**Development Application – Proposed Retaining Walls
Lot 16 (14) Terry Deschamps Way, Denham**

Planning Justification Cover Letter – Lot 16 (No. 14) Terry Deschamps Way, Denham – Proposed Retaining

RE: Lot 16 (#14) Terry Deschamps Way, Denham: Design Guideline Resubmission Review/Assessment

PRELIM DESIGN PEDERSEN 080925
TERRY DESHAMPS WAY DENHAM

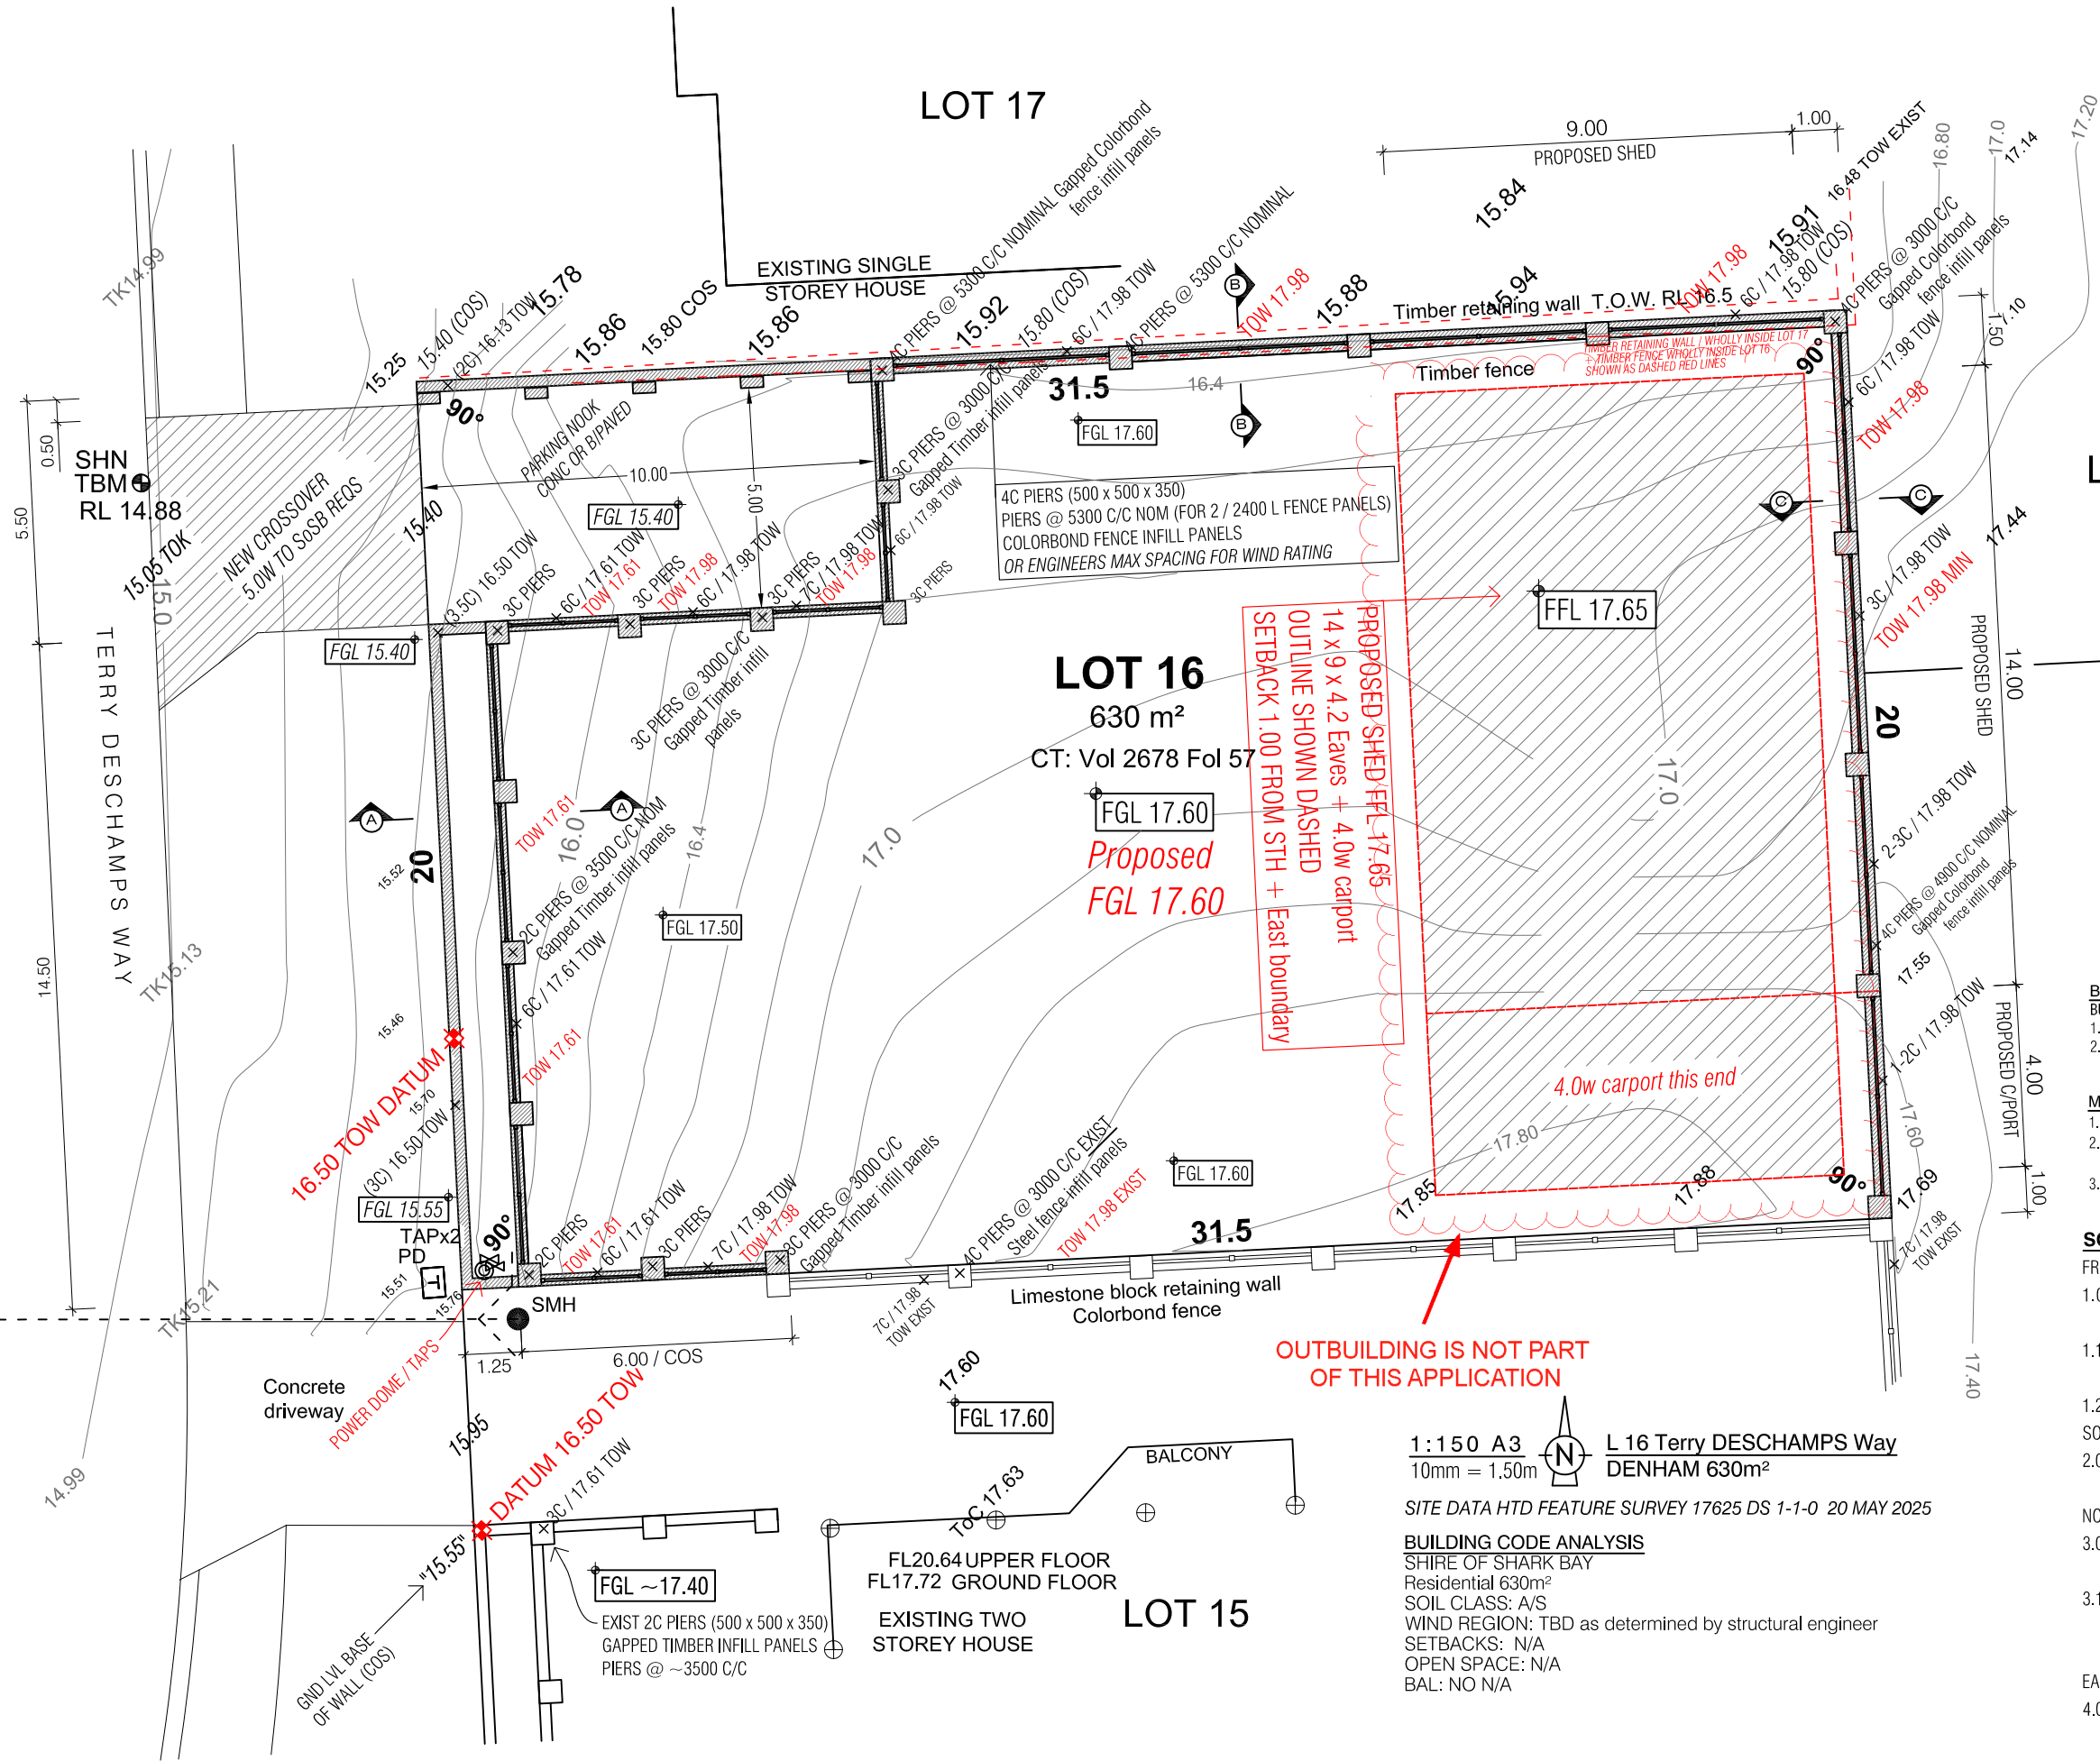
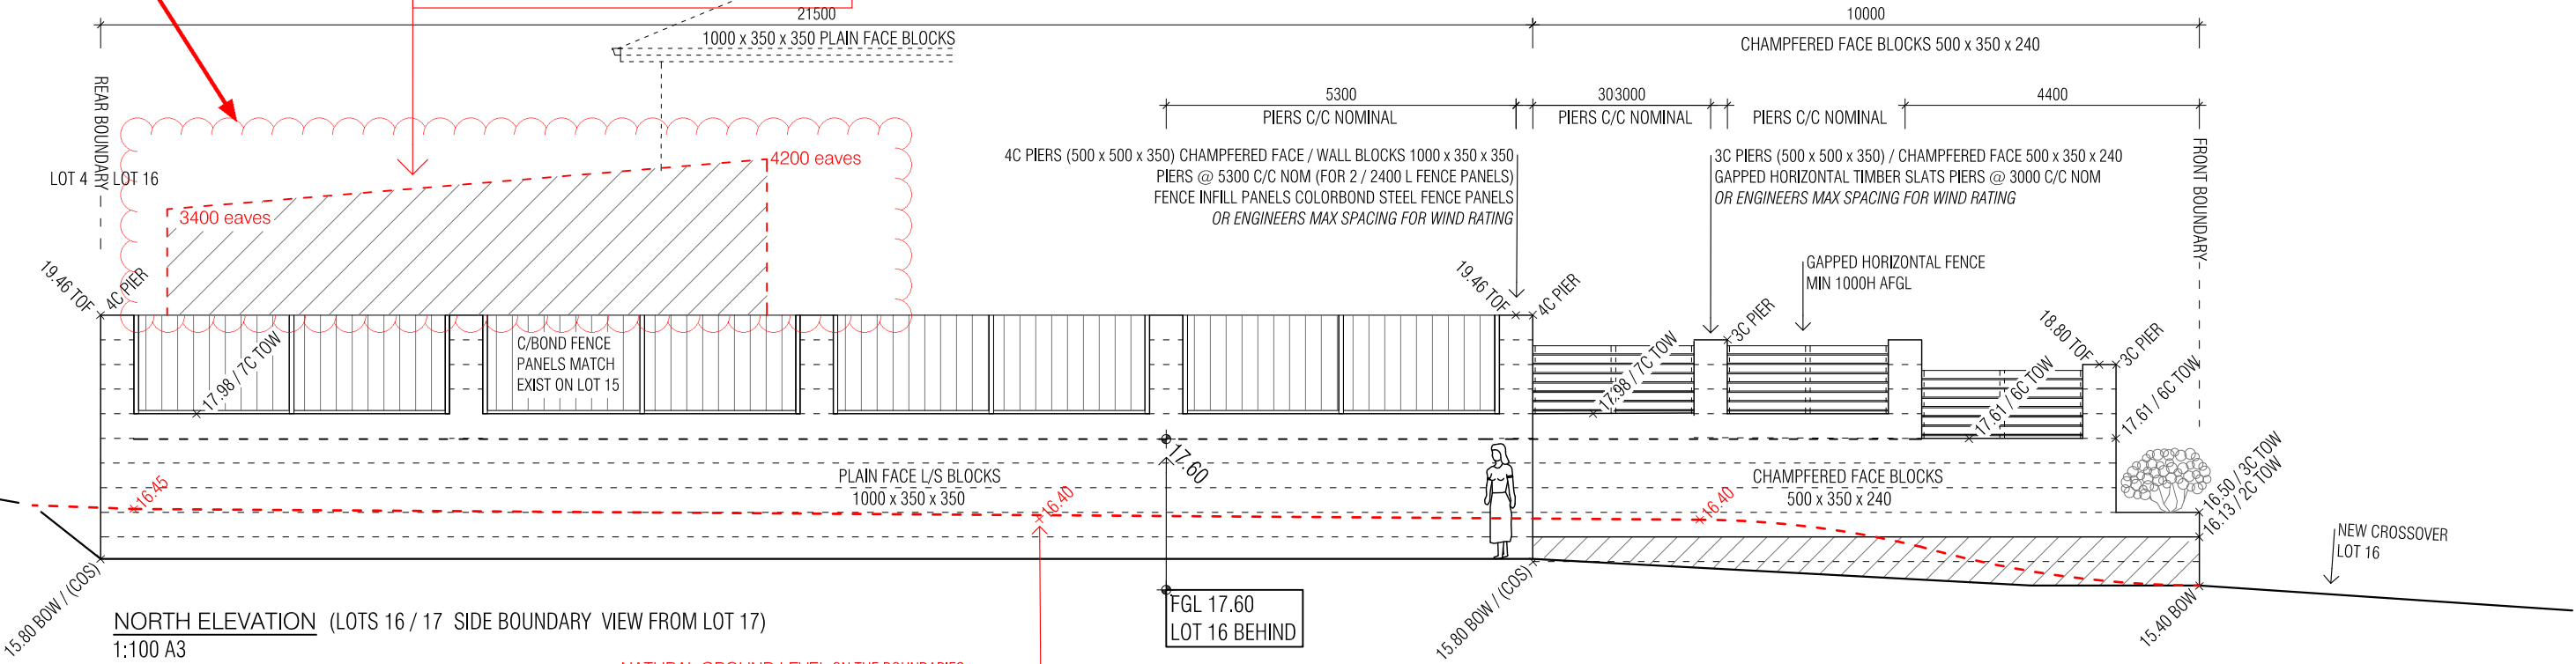
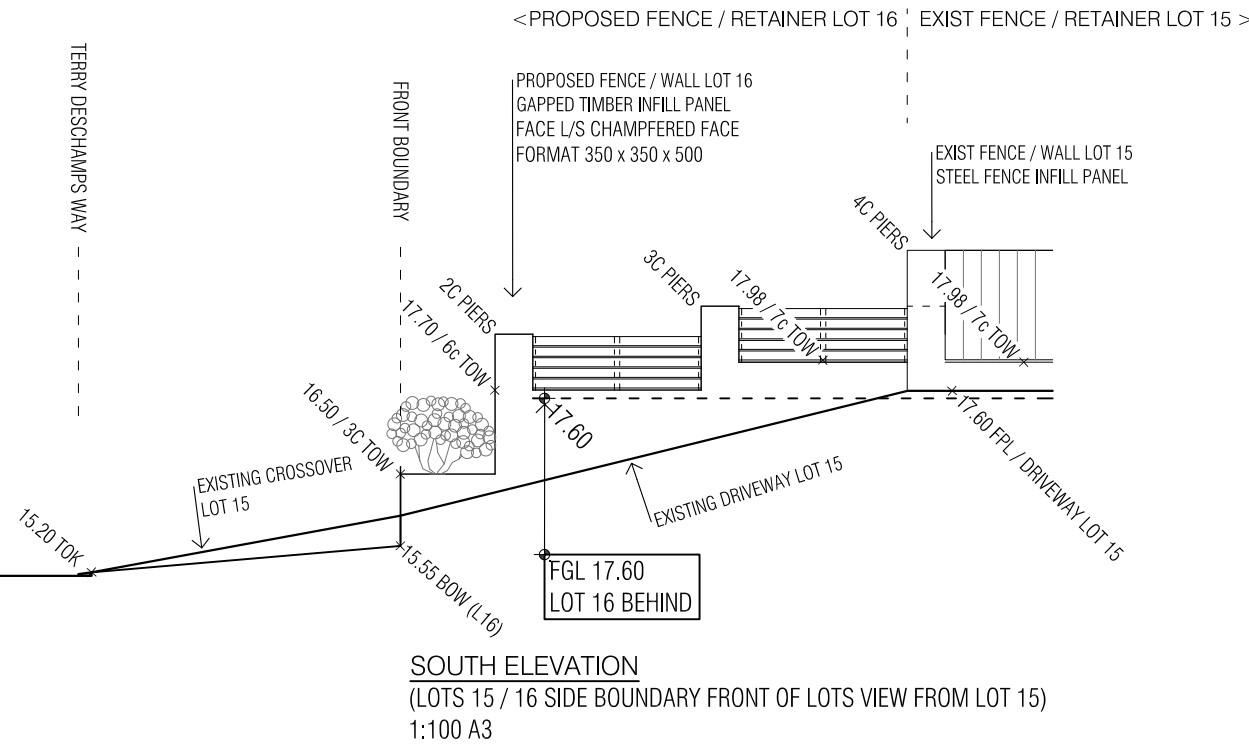
- **Item 03: Proposed Retaining and Fencing**
 - Applicant Resubmission (09.09.25)
 - Whilst the retaining wall top-of-walls originally proposed have generally been maintained, clarity on the originally natural grounds levels have been clearly indicated for consideration.

- **Item 04: Dunal Heath Retention Zone (Landscaping)**
 - Applicant Resubmission (09.09.25)
 - Confirming this resubmission package has retained the originally proposed retaining wall extents to the property boundary - forgoing the DG requirement for a 2m deep Dunal Heath Zone identified in *CL 8.3.1 Landscaping*.

- **Current DG review/assessment on this item:**
 - On review of the provided justification, we note:
 - i. Established Precedent: RE the suggested non-compliance of a number of surrounding developments within the estate. We note the requirement for conformance with DG CL 8.3.1 Landscaping requirement for the retention of a 2m wide dunal heath strip along the length of the front boundary has not previously been waived in DG Compliance Assessments. Any perceived post-approval DG non-compliances constructed falls outside the remit of this Design Guideline compliance assessment and accordingly not a supported justification to deviate from the DGs.

ii. Site Amalgamation Context: RE Design consistency and visual integration with the existing dwelling on the adjacent Lot 15 (#12): The proposal to omit a 2m dunal heath zone from the proposed development on Lot 16 for consistency with the adjacent Lot 15 (#12) development is not a supported justification to deviate from the requirements of *DG Cl 8.3.1 Landscaping*. This is with consideration that:

Accordingly, we confirm the proposed omission of a 2m dunal heath zone on the proposed development on Lot 16 is not supported due to its non-compliance with the *DG CL 8.3.1 Landscaping* – adjustment of the proposed retaining wall extents is required for conformance with the DG requirements.

- **Current DG review/assessment on this item:**
 - Acknowledging the proposed setback clarifications requested - we have no further comment/clarification requests on this item and revert assessment for compliance with associated statutory requirements to the LGA.
